**TOWN OF CARMEL**  
**PLANNING BOARD**

**PLANNING BOARD AGENDA**  
**DECEMBER 14, 2023– 7:00 P.M.**

RE: Carmel Fire Department  
94 Gleneida Avenue  
Town of Carmel  
TM# 44.14-1-24

**3 WALL SHELTER DETAIL**  
(N.T.S.)

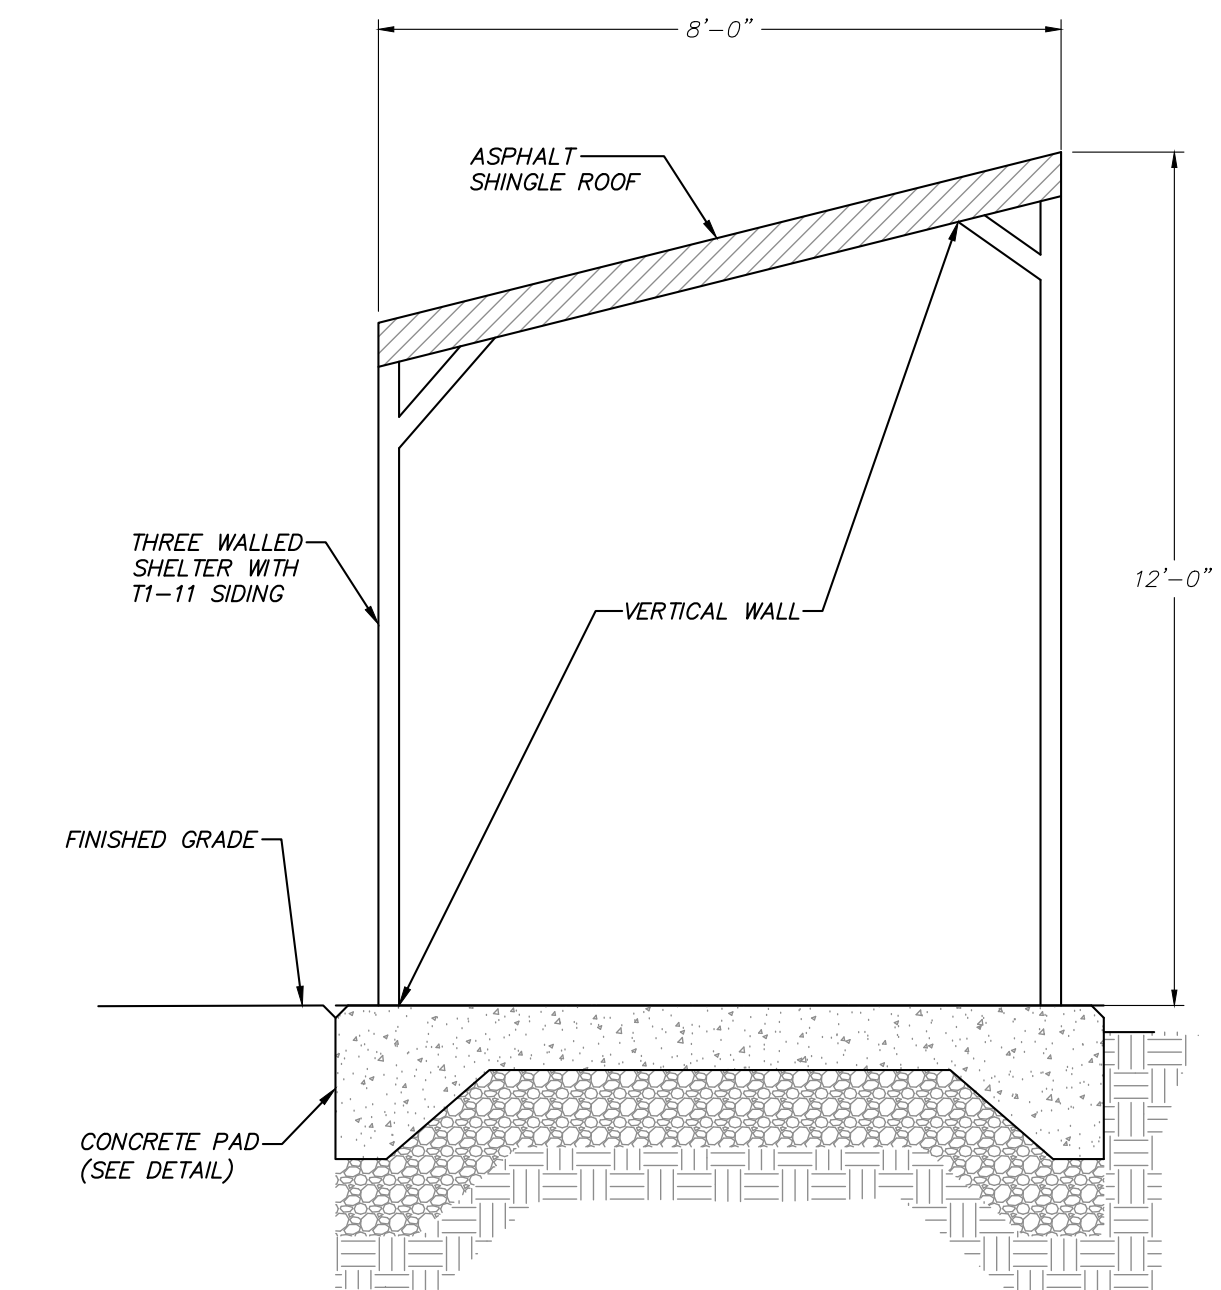
- Based on our research, there does not appear to be a separate easement description filed for the sewer easement. File Maps #1597, #1090 D and #1090 U do not indicate restrictions as to what can be built over the easement; therefore it is believed the proposed improvements are permitted. The applicant understands that the proposed improvements would have to be removed or relocated if repair to the Town sewer line would be required in the future.
- No outdoor lighting is proposed.
- The three walled structure will be stick built with T1-11 siding with stain to match existing site features and an asphalt shingle roof. This information has been added to Drawing D-1.

PROJECT NUMBER: 21120.100 PROJECT MANAGER: J.J.C. DRAWING NO. SHEET: 3  
DATE: 8-30-23 DRAWN BY: I.B. SP-1.1  
SCALE: 1"=50' CHECKED BY: A.D.T.

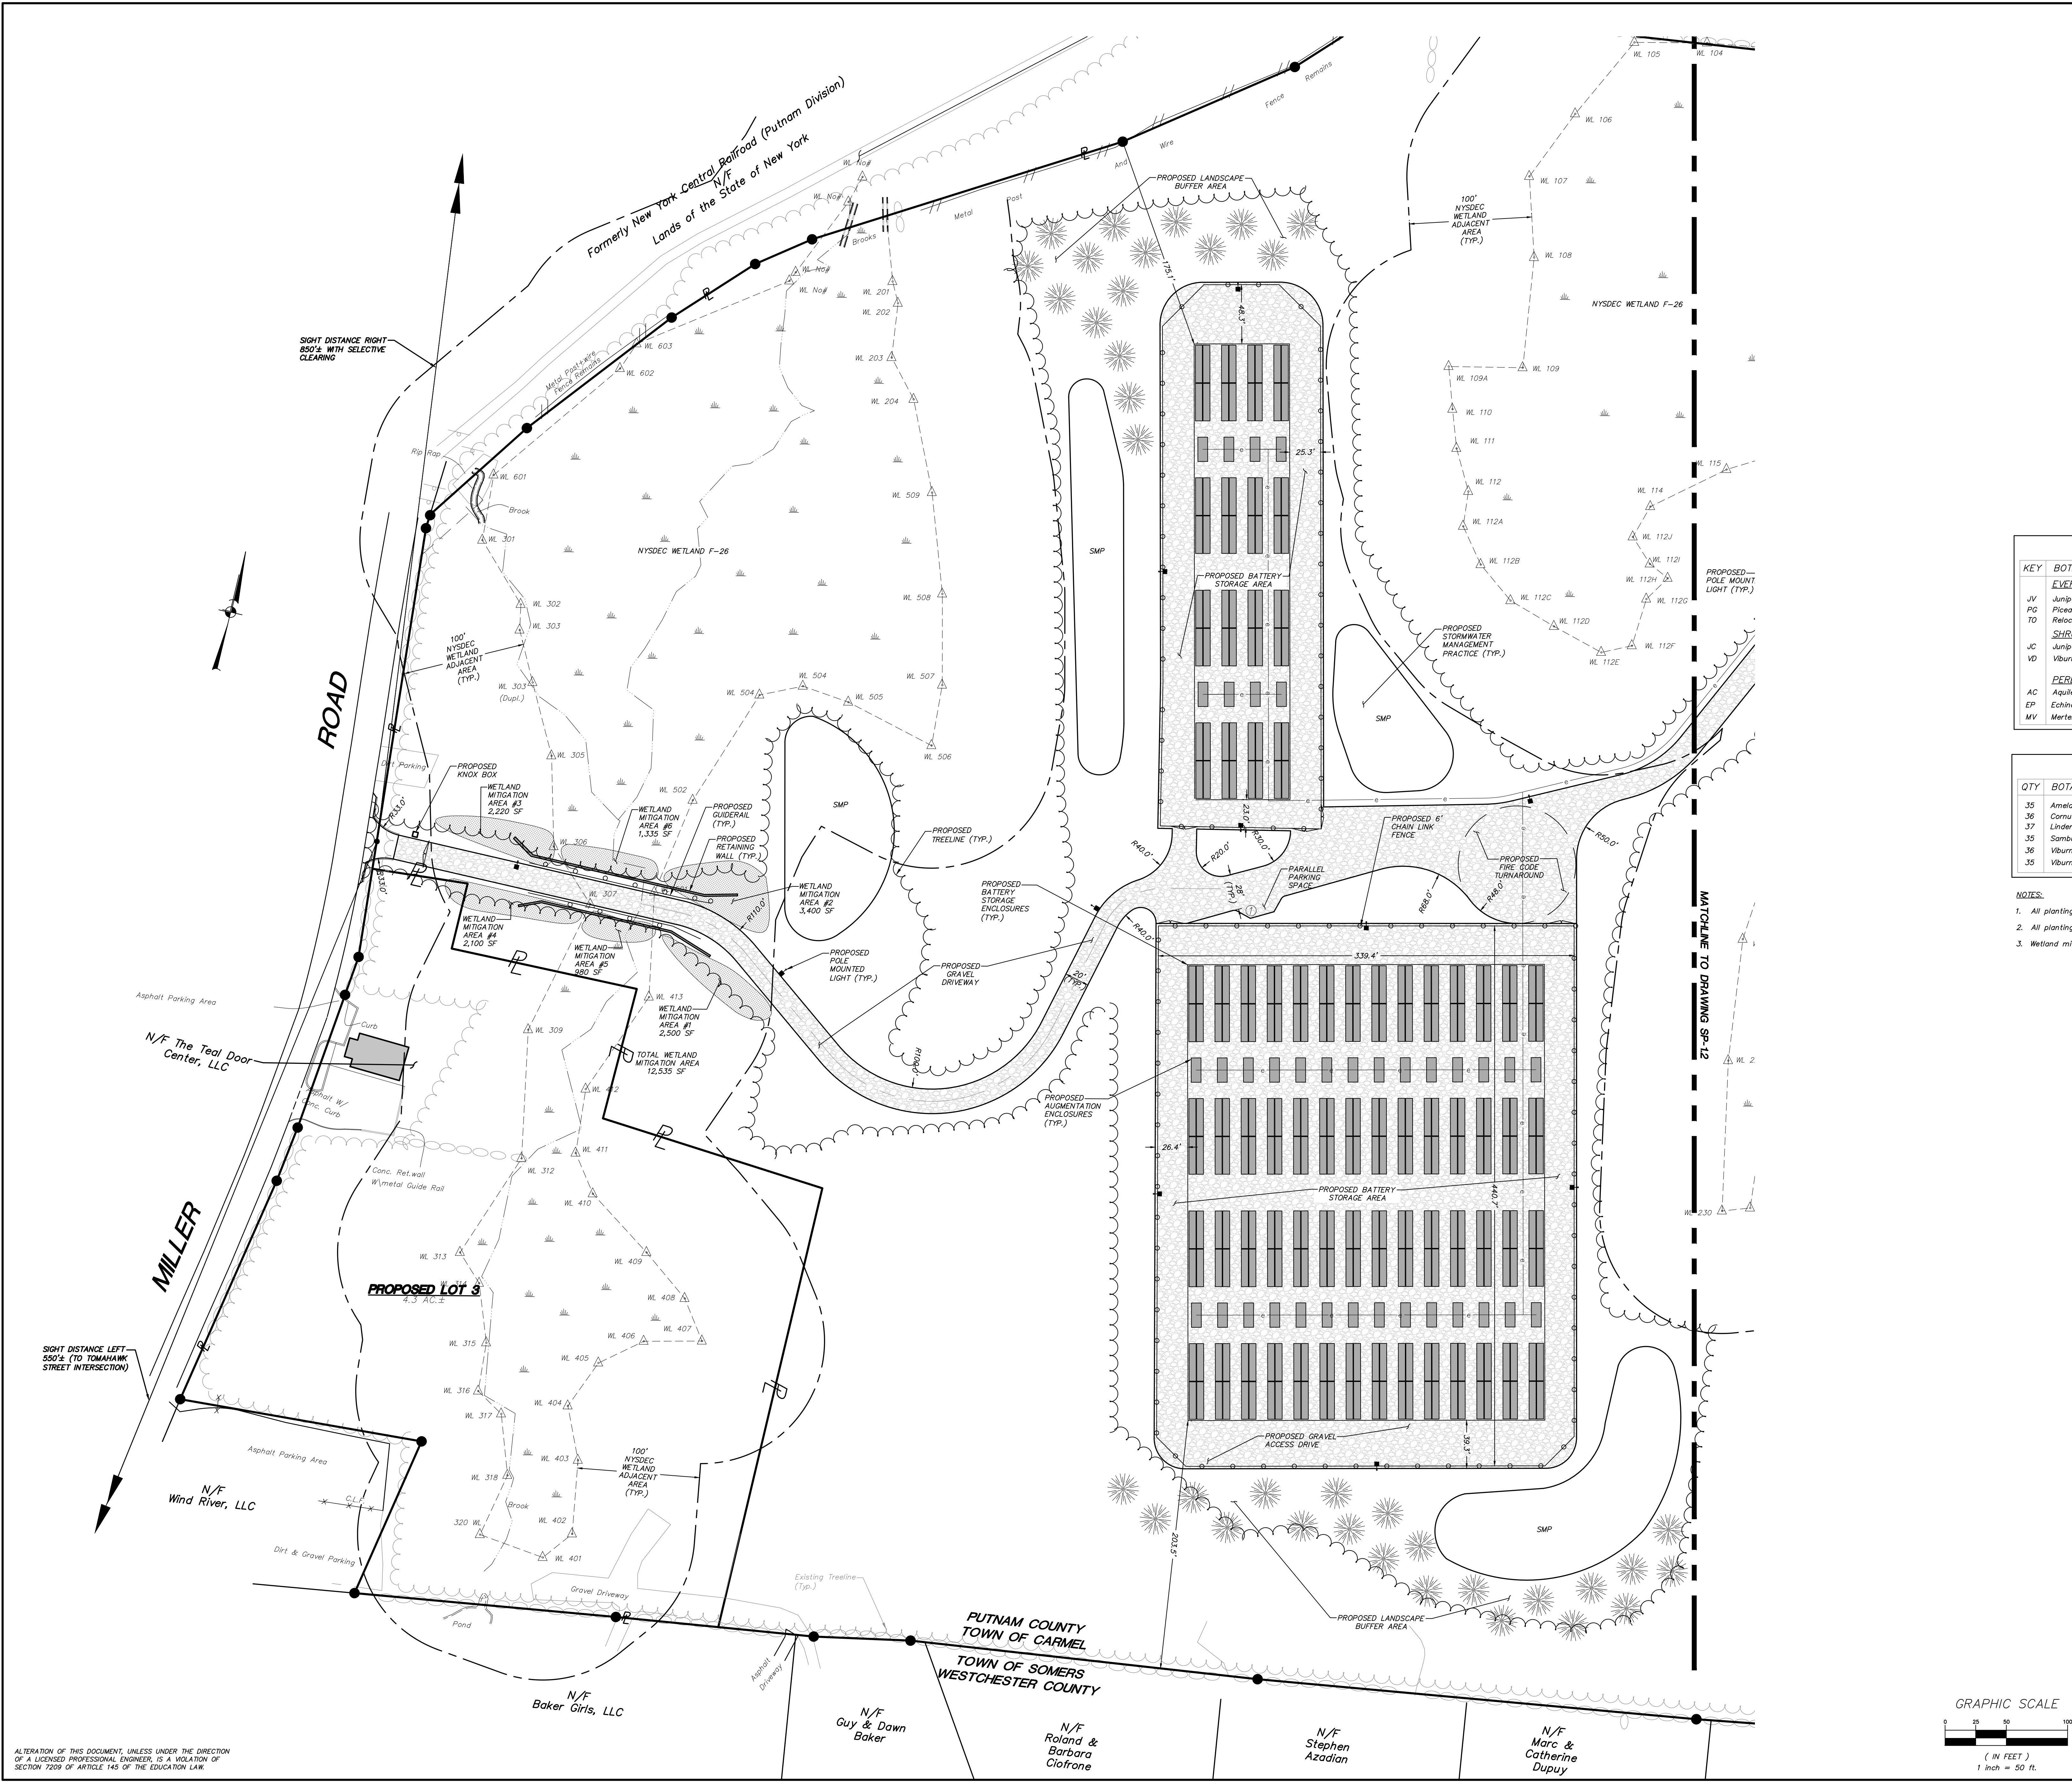
- 1. A Vehicle Maneuvering Plan.
  - a. Sight distances are provided on drawing SP-1.1. They have been added to the Maneuvering plan on drawing SP-4.1.
  - b. Driveway profiles will be provided with a future submission.
- 2. Layout and Landscape Plans
  - a. A Photometric Plan is provided on drawing SP-4.2.
- 3. Grading and Utilities Plans
  - a. Rims and inverts will be provided with a future submission.
  - b. Hydraulic calculations and pipe sizes will be provided with a future submission.
